Invitation For Bid: IFB-01-ENG-2025

Project: Design-Build of Upper Tumon Warehouse Renovation
GWA Project No. 42102

Addendum No.: **02**

Date: February 05, 2025

1 EXTENSION
HORIZ. SCALE: 1"=8'-0"

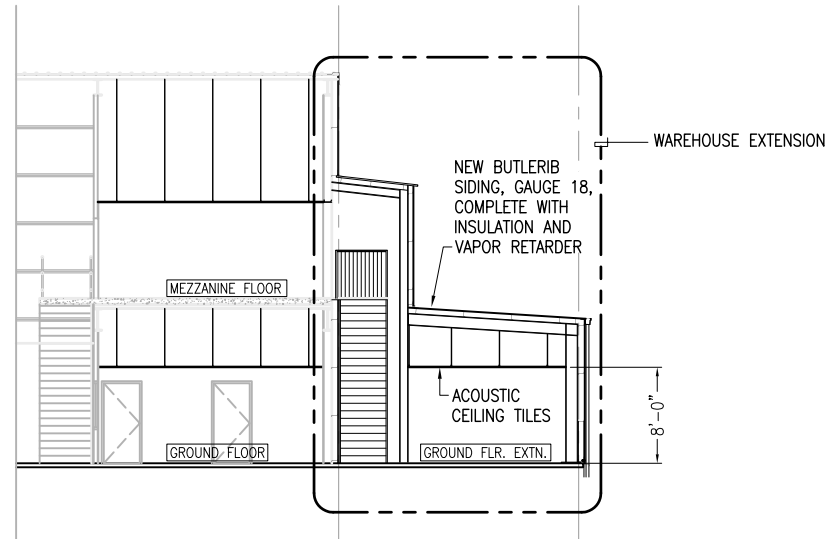
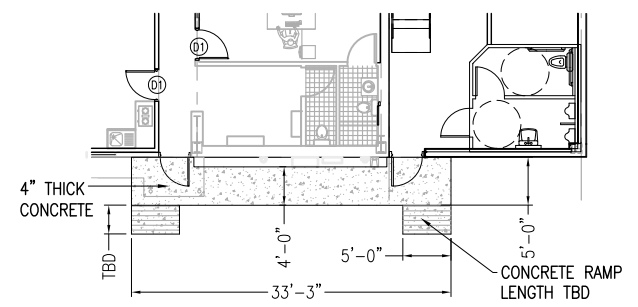
2.0	Warehouse Extension				
2.1	Construct a warehouse extension (20'x80') at eastern side of existing warehouse complete and operational including but not limited to civil works including water and sewer service connections, structural, mechanical including sprinkler system and air-conditioning system, plumbing, electrical, CCTV and telecommunication per drawing layout on Sheet C-12.	1	LS	\$	\$
Total Additive Bid					\$
Write out total additive bid amount in words below

1. THIS WAREHOUSE EXTENSION IS AN ADDITIVE BID ITEM.
2. THIS DRAWING SHOWS CONCEPT LAYOUT. THE DESIGN-BUILDER IS RESPONSIBLE IN COMPLETING THE DESIGN DRAWINGS INCLUDING ARCHITECTURAL, STRUCTURAL, MECHANICAL INCLUDING SPRINKLER SYSTEM, ELECTRICAL, TELECOMMUNICATION, AND PLUMBING.
3. ALL OFFICES ARE TO BE PROVIDED WITH ACCU.
4. ALL DRAWINGS ARE SUBJECT GWA APPROVAL.
5. THE WAREHOUSE EXTENSION SHALL COMPLY WITH THE MINIMUM ADA REQUIREMENTS.
6. PROVIDE ADA ACCESS BETWEEN THE ENTRANCE TO EXISTING WAREHOUSE AND ENTRANCE TO WAREHOUSE EXTENSION.
7. SUPPLY OF FURNITURE, FIXTURES, AND EQUIPMENT (FFE) ARE NOT INCLUDED IN THE PROJECT SCOPE.
8. DOOR ORIENTATIONS CAN BE ADJUSTED.
9. LAYOUT OF ADA RESTROOM CAN BE ADJUSTED.
10. REFER TO EXHIBIT "B" ADDENDUM NO. 2 FOR POSSIBLE CONNECTION OF WATER AND SEWER SERVICE.
